PRODUCT CHANGE NOTIFICATION (PCN)

AMJE0909-0030-GNB-24
MODULAR CABLE

CHANGE NOTIFICATION: PCN 20220509_AMJE0909-0030-GNB-24

DESCRIPTION OF CHANGES:
CHANGE OF DATA SHEET
CHANGE OF DATA SHEET
New Draw.-No. ASS_7945_CArev02

AMJE0909-0030-GNB-24 OLD VERSION

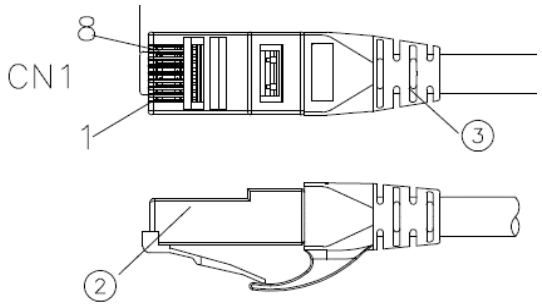
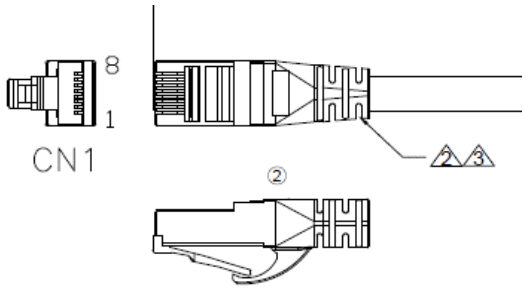
③	Molding	PVC 45P Color: see order code	NA	KG
②	CONNECTOR	RJ45 8P8C two fork Short type 3u" gold plated	2	PCS
①	CABLE	CAT6 UTP (24AWG*1PR)*4+PVC OD=5.8±0.3MM Color: see order code	NA	MM
NO:	NAME	DESCRIPTION	Q'TY	UNIT

3	Molding	PVC 65P Color: see order code ②	NA	KG
2	CONNECTOR	RJ45 8P8C PLUG 3u" gold plated ②	2	PCS
1	CABLE	CAT6 U/UTP (24AWG*1PR)*4+Cross+PVC Jacket OD=5.8± 0.3MM Color: see order code ②	NA	MM
NO:	NAME	DESCRIPTION	Q'TY	UNIT

Drawing-No.
ASS 7945 CA

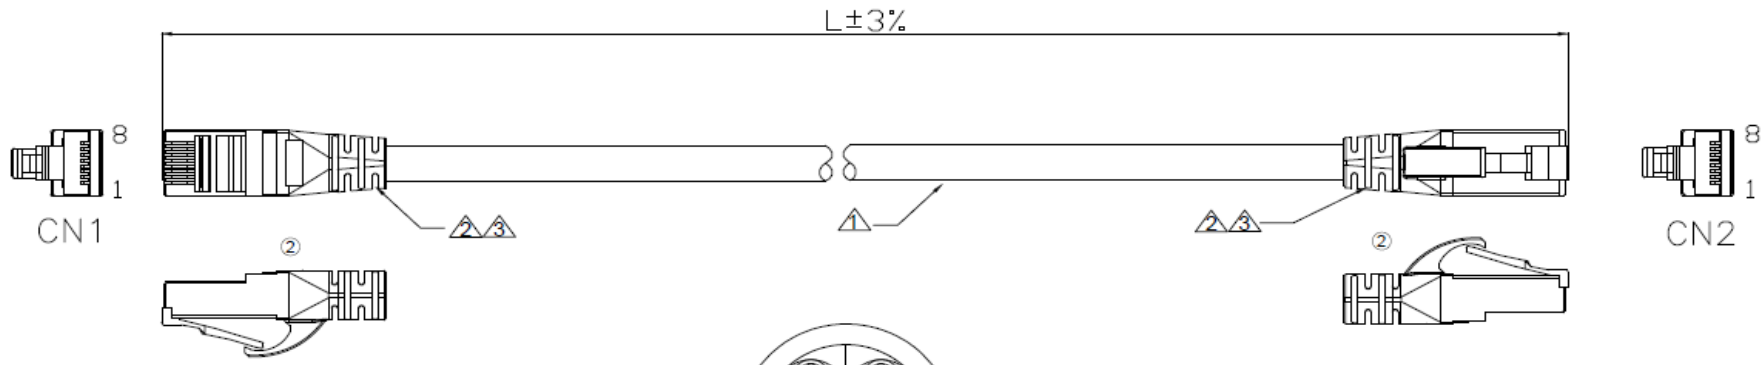
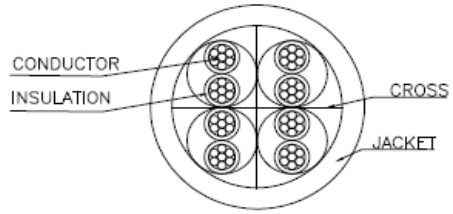
Id.	Modification	Date	Name
②	Change the plant	09.05.2022	Luca
①	Update the WSW order code	02.06.2017	Amy
⓪	Drawn	30.03.2017	Amy

NO:	NAME	DESCRIPTION	Q'TY	UNIT
3	Molding	PVC 65P Color: see order code ②	NA	KG
2	CONNECTOR	RJ45 8P8C PLUG 3u" gold plated ②	2	PCS
1	CABLE	CAT6 U/UTP (24AWG*1PR)*4+Cross+PVC Jacket OD=5.8± 0.3MM Color: see order code ②	NA	MM
